ST. TERESA'S COURT SUBDIVISION,
RESUBDIVISION OF LOTS 6, 7 AND 8, BLOCK 1

APPLICATION NUMBER 23 DATE June 4, 2009
 APPLICANT St. Teresa's Court, Resubdivision of Lots 6, 7, and 8, Block 1
 REQUEST Subdivision

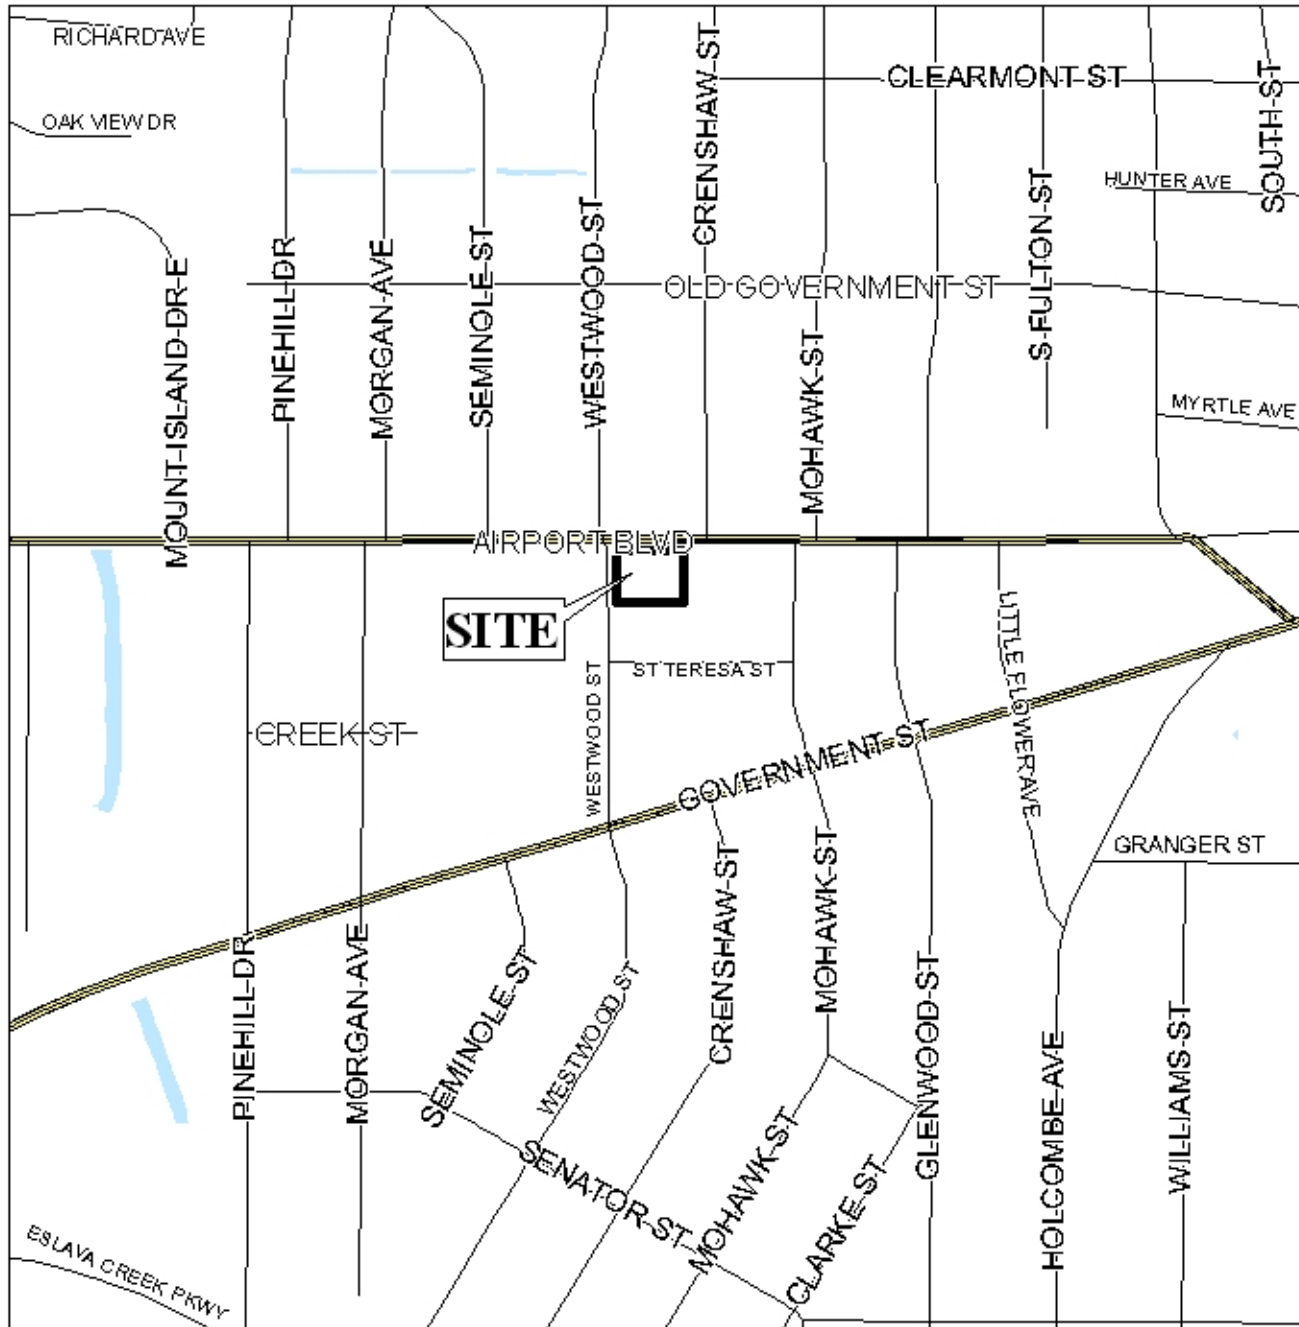
As illustrated on the preliminary plat the site is located on the southeast corner of Airport Boulevard and Westwood Street. Airport Boulevard, has an existing right-of-way of 60-feet as illustrated on the preliminary plat; however Airport Boulevard is shown as a major street on the Major Street Component of the Comprehensive Master Plan, and as such requires an 80-foot right-of-way. Therefore, the dedication of sufficient right-of-way to provide 40-feet from the centerline of Airport Boulevard should be required. Westwood Street complies with the standards of the minor street requirements; therefore, no dedication is required along Westwood Street.

With the site being located on a major street and at an intersection, access management is a concern; therefore, the placement of a note on the Final Plat stating that Lot 1 be limited to the existing curb cuts and Lot 2 be allowed one curb cut, with the design, size and location to be approved by Traffic Engineering and conform to AASHTO standards.

It should also be noted the proposed Lot 1 is currently developed with a fast food restaurant; therefore, the applicant should be made aware that the approval of the preliminary plat may create a zoning violation and should locate all buildings, parking, access, landscaping and trees for staff review prior to the signing of the Final Plat.

- 1) the dedication of sufficient right-of-way to provide 40-feet from the centerline of Airport Boulevard;
- 2) the placement of a note on the Final Plat stating that Lot 1 be limited to the existing curb cuts and Lot 2 is limited to one curb cut onto Airport Boulevard, with the design, size and location to be approved by Traffic Engineering and conform to AASHTO standards; and
- 3) verification that the subdivision will not create a violation of the zoning Ordinance prior to the signing of the Final Plat.
